ROCKY FLATS ENVIRONMENTAL TECHNOLOGY SITE FINAL PHASE I RFI/RI WORK PLAN FOR OPERABLE UNIT 5 WOMAN CREEK PRIORITY DRAINAGE	Manual No.: Procedure No.: Page: Effective Date: Organization:	21100-WP-OU 05.1 Table of Contents, Rev 10 1 of 2 02/07/95 Environmental Management
--	--	---

DMR. No. 95-DMR-ERM-DD15

2. or 3. Document Number/Revision WP-OU05.1/Rev. 9	3. Document Title: FINAL PHASE I RFI/RI WORKPLAN FOR OPERABLE UNIT 5 WOMAN CREEK PRIORITY DRAINAGE, Volume III - Text to Technical Memorandum No. 15 - Amended Field Sampling Plan
---	--

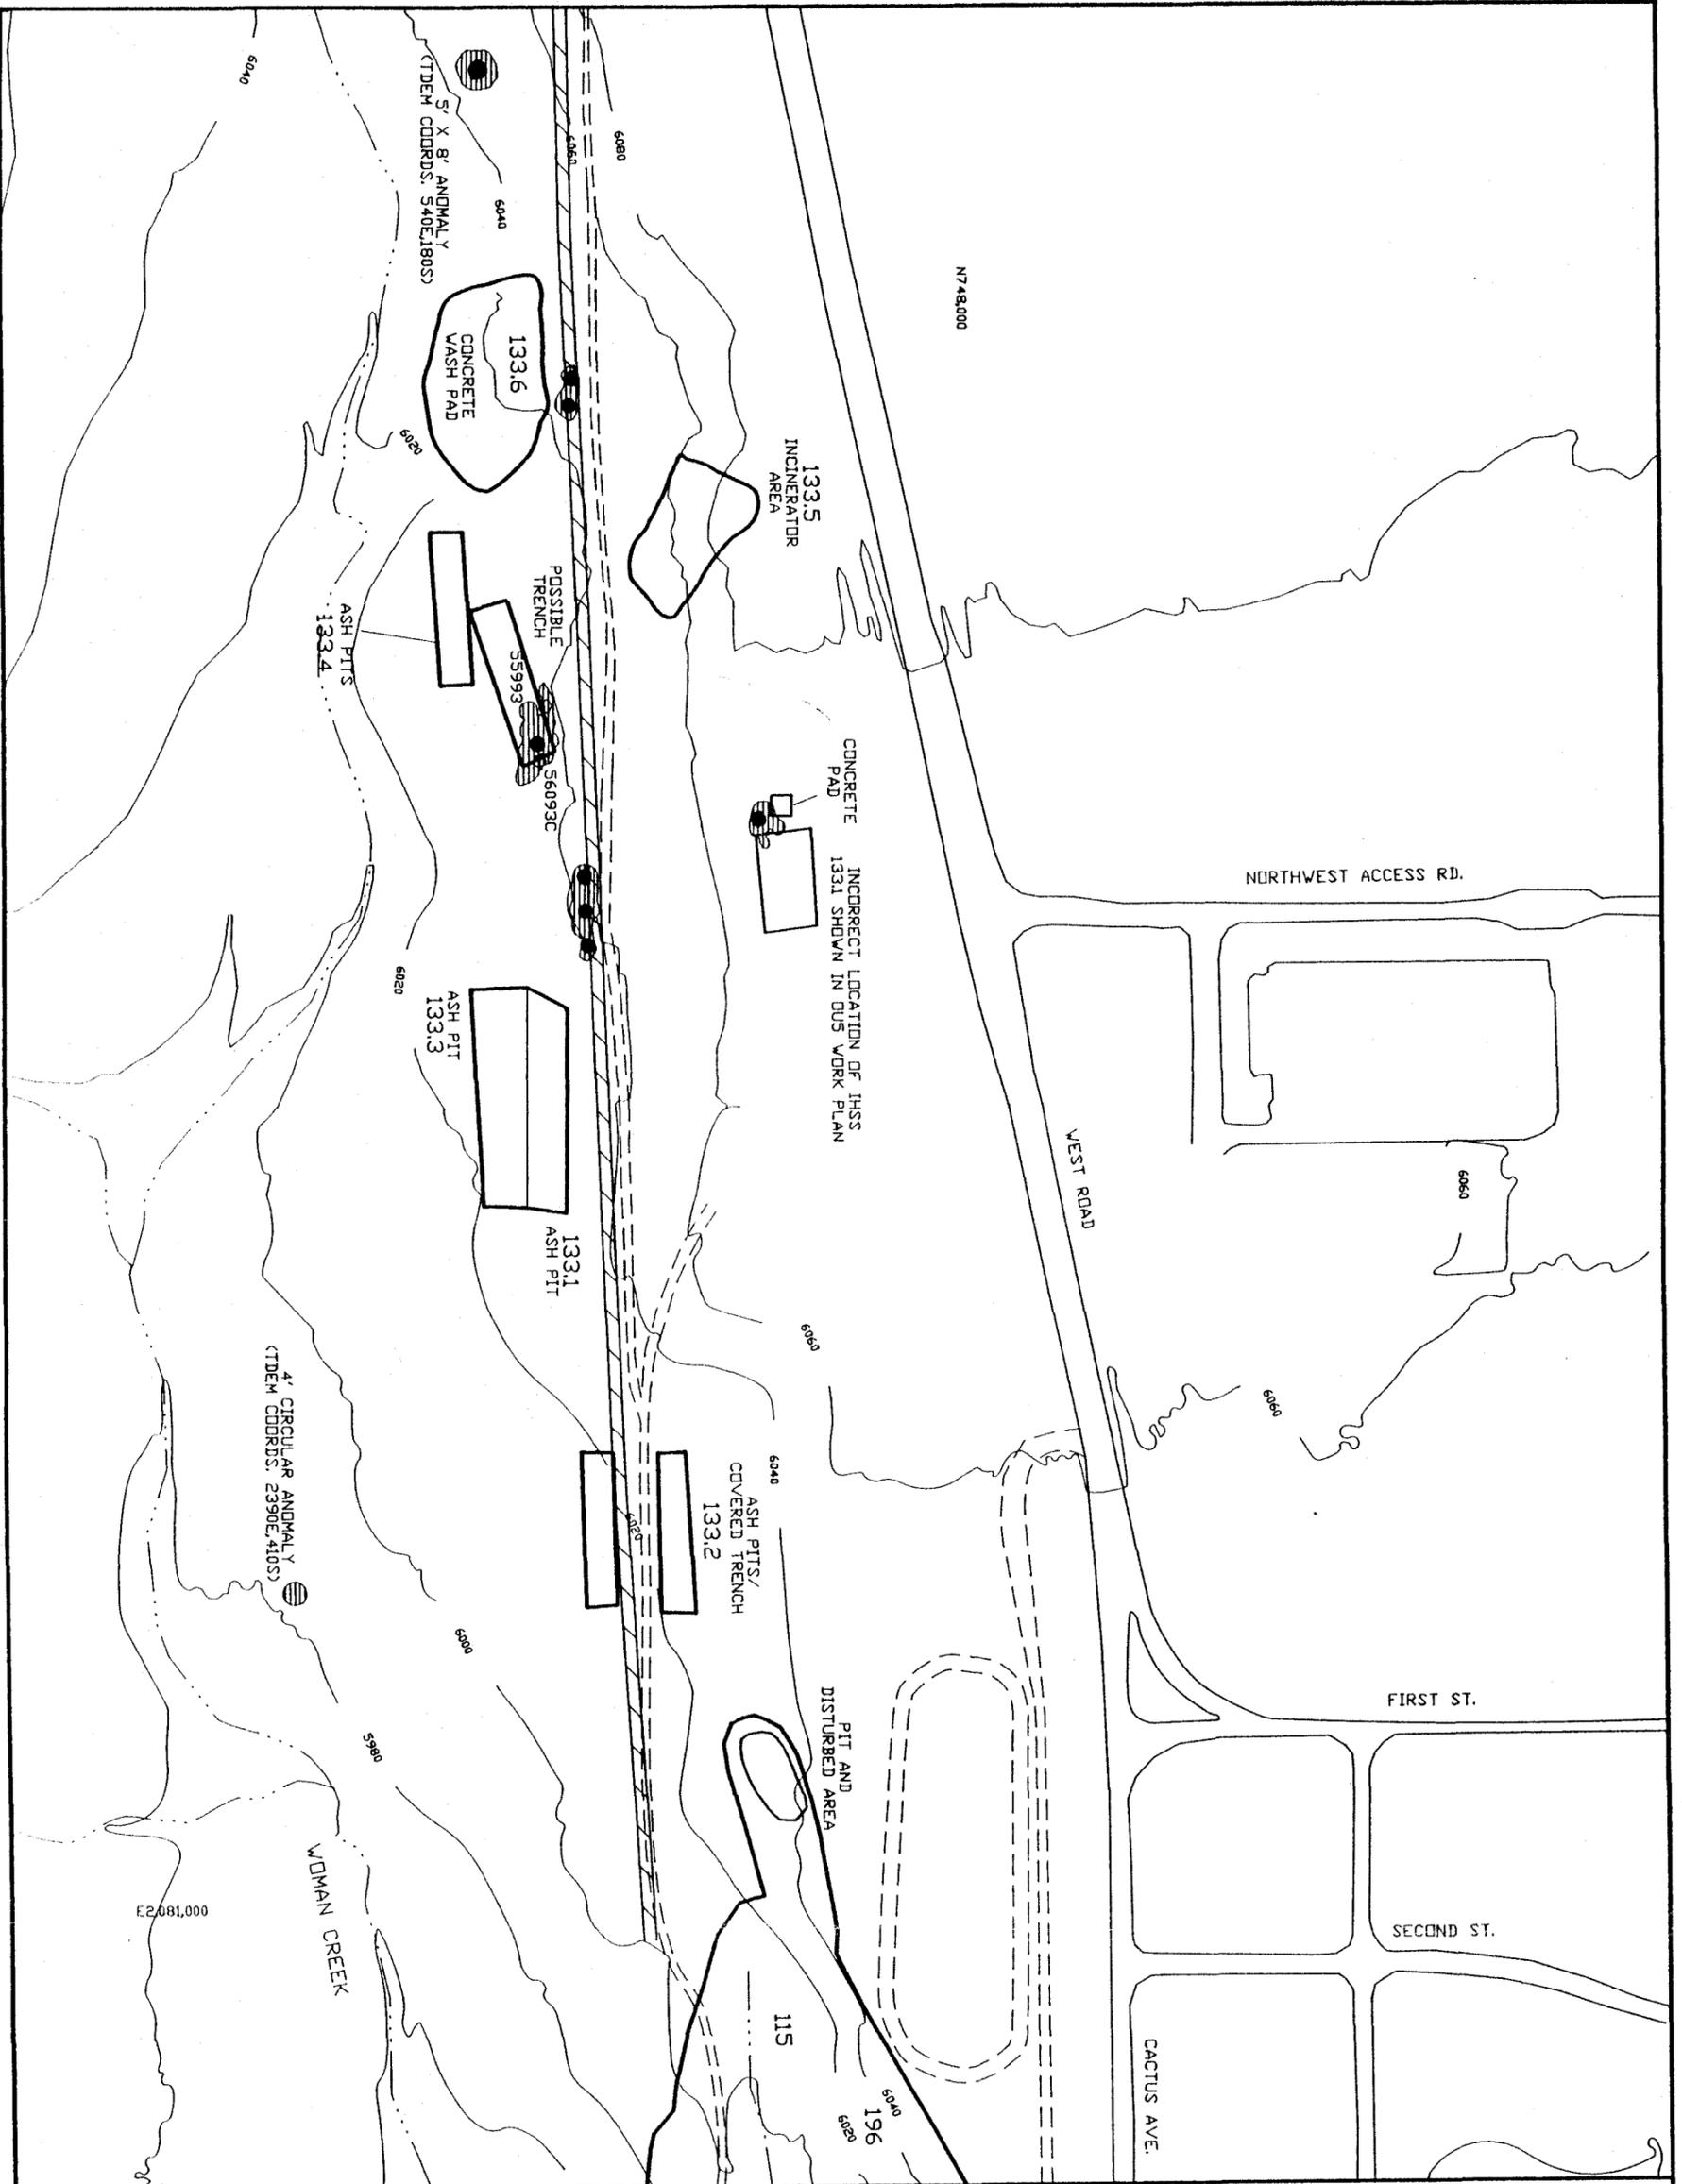
An eighth borehole will be drilled to geologically and chemically characterize the surface and subsurface materials in the additional TDEM anomaly identified at TDEM survey coordinates 540 East and 180 South (Figure 3.2.2.1-1). The area is approximately 5 by 8 feet in area and described as a small oblong mound.

HPGe AND FIDLER SURVEY LOCATIONS IHSS 209 AND SURFACE DISTURBANCE WEST OF IHSS 209

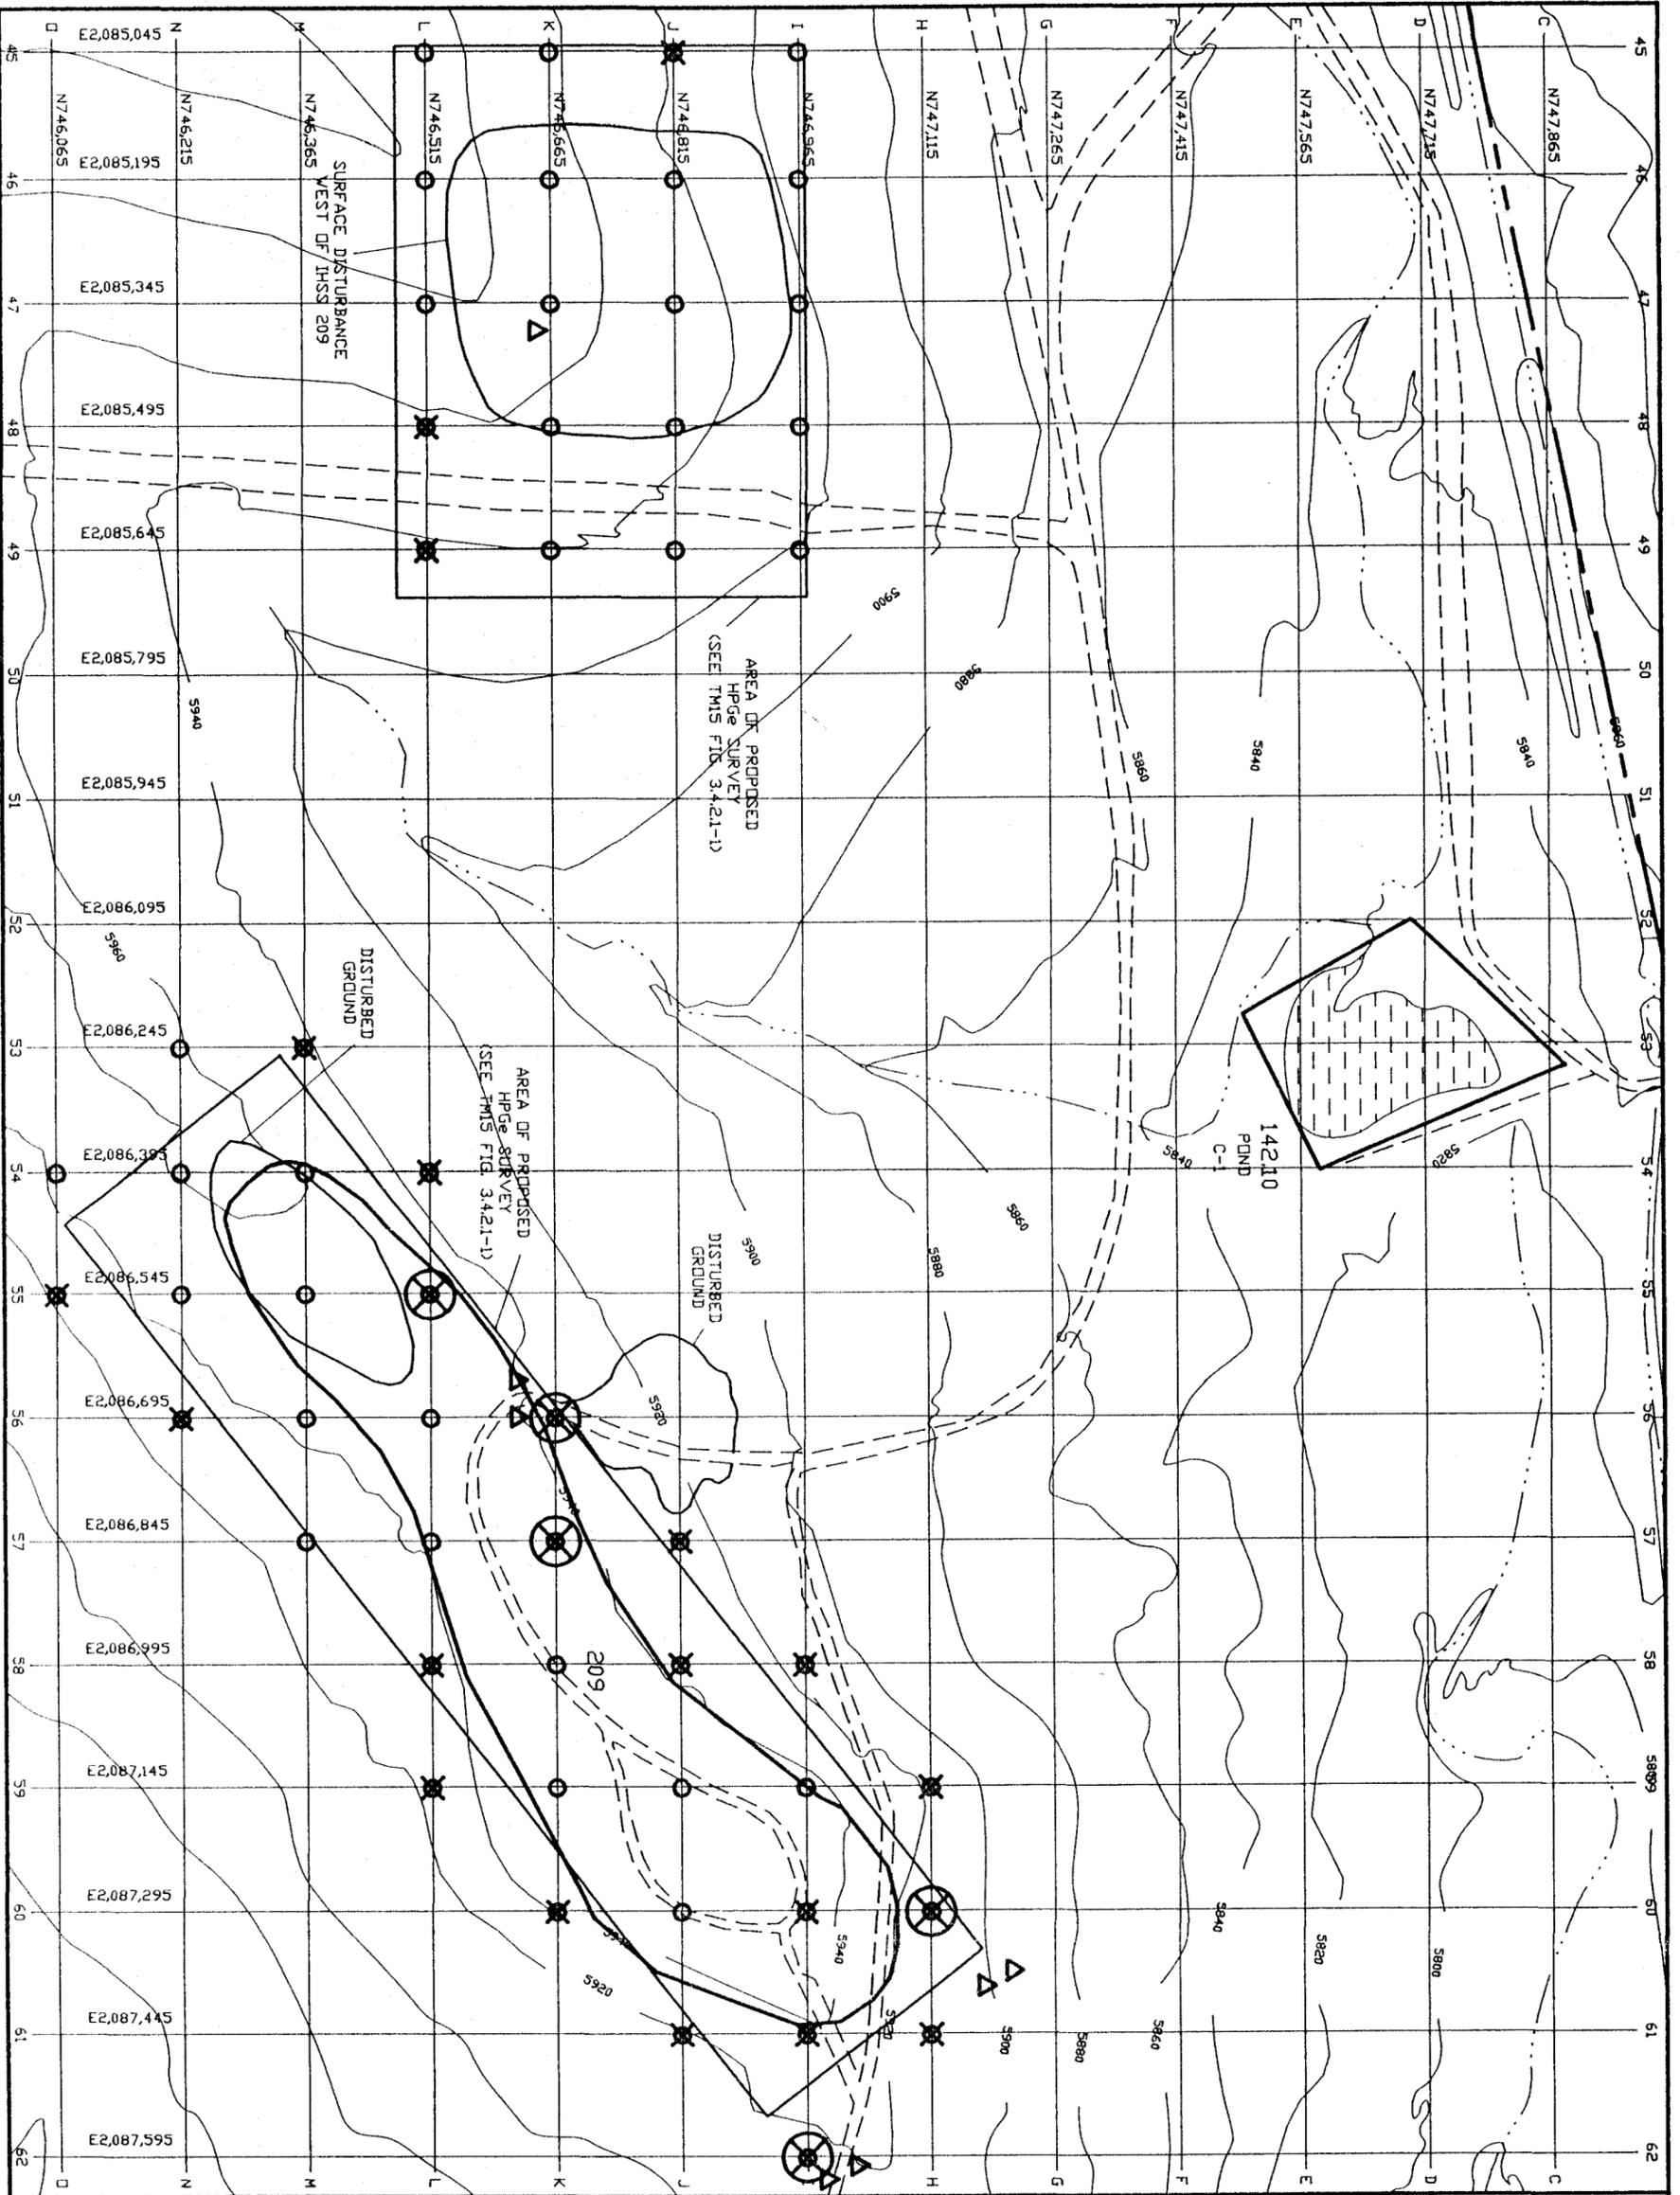
A total of six samples will be collected from the five anomalies within IHSS 209 (Figure 3.4.2.1-3). One sample each will be collected at anomalies K-56A and L-55A. Two samples each will be collected from the anomalies identified at stations H-60 and I-62. The relatively low activities detected with the FIDLER at the latter two stations do not warrant the collection of surface-soil samples at the location of each anomaly. Therefore, one sample will be collected

at the two anomalies with the greatest number of counts. At station H-60, one sample will be collected at coordinates 8 West/65 North and one will be collected at coordinates 28 West/96 North. Similarly, one sample will be collected from the two anomalies with the greatest number of counts at station I-62 (coordinates 92 West/50 North and 66 West/30 North). Due to the relatively low activities detected with the FIDLER at anomaly K-57A, the collection of surface-soil samples at this location is not warranted.

One sample will be collected from anomaly M-14A at the Surface Disturbance South of the Ash Pits (Figure 3.4.2.1-4). As discussed in Section 3.4.1, a relatively high activity of plutonium-239/240 was detected in a surface soil sample collected from the Surface Disturbance West of IHSS 209 (sample SS50075AS). The plutonium-239/240 activity detected at this location was the primary reason that additional radiological surveys and surface-soil sampling was necessary at these sites. Although, the HPGe survey did not detect americium-241 and plutonium-239/240 in the vicinity of this location, an additional surface soil sample will be collected at this location (Figure 3.4.2.1-3) as a verification and quality-control check.
